Agenda Supplement

November 8, 2023
HDC Meeting

Applicant Submitted Information

Proposed Development – “Gateway” Apartment Complex

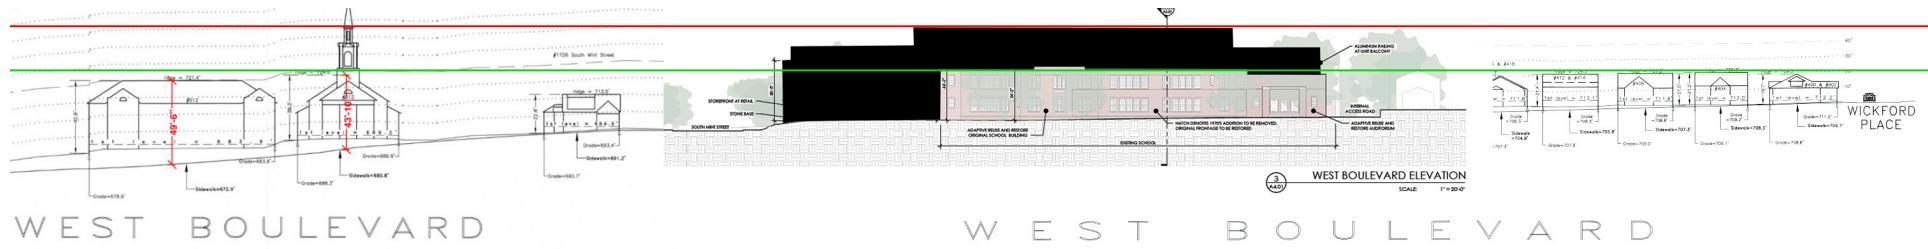
Proposed towers will be significantly visible from different pedestrian viewpoints.

This will undermine the Historic Wilmore School and the context of the neighborhood.

Proposed Development – Townhomes on W. Kingston

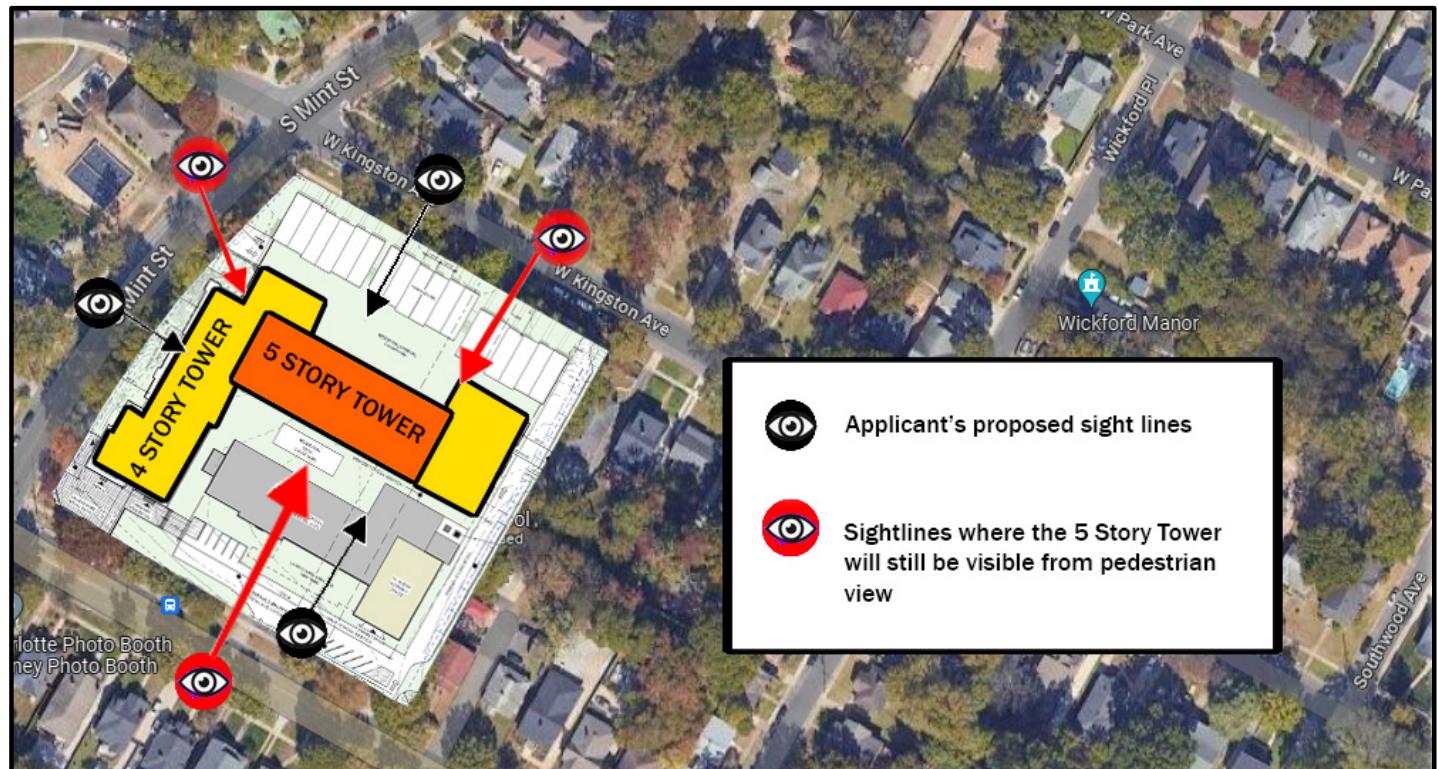
Scale of the Proposed Development on West Kingston does NOT respect immediate historic context of neighboring homes.
